TECHNICAL SERVICE BULLETIN

SUBJECT: Improved Ground Speed/Foot Count Sensor

MODELS BR and SR Series Harvesters

Figure 1—Ground speed sensor on BR models.

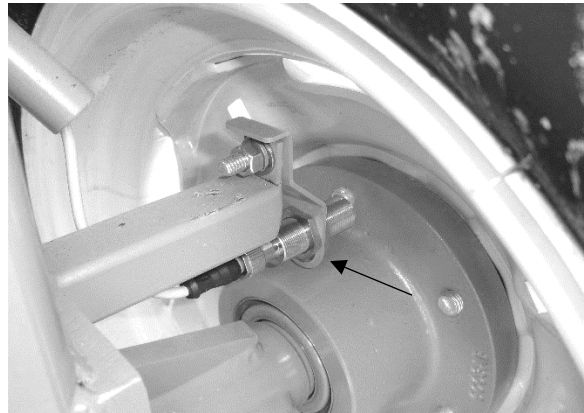
4. Attach the new mounting bracket to the existing reed switch mounting fixture using the provided fastener. See **Figure 1** (BR models) or **Figure 2** (SR models). Do not tighten the bracket fastener yet.

5. Install the sensor into the bracket. On BR models, carefully adjust the sensor mounting bracket so the tip of the sensor is aligned with the wheel studs protruding through the hub. See **Figure 1**. On SR models adjust the bracket so the tip of the sensor is aligned with the rounded tip of the hub casting as shown in **Figure 2**.

6. Tighten the bracket fastener.
7. Adjust the sensor inward or outward as necessary to obtain 1/8 to 3/16 in. (3.2-4.8 mm) air gap between the tip of the sensor and the wheel studs (BR) or hub casting (SR). Securely tighten the sensor nuts while making sure the air gap remains as specified.
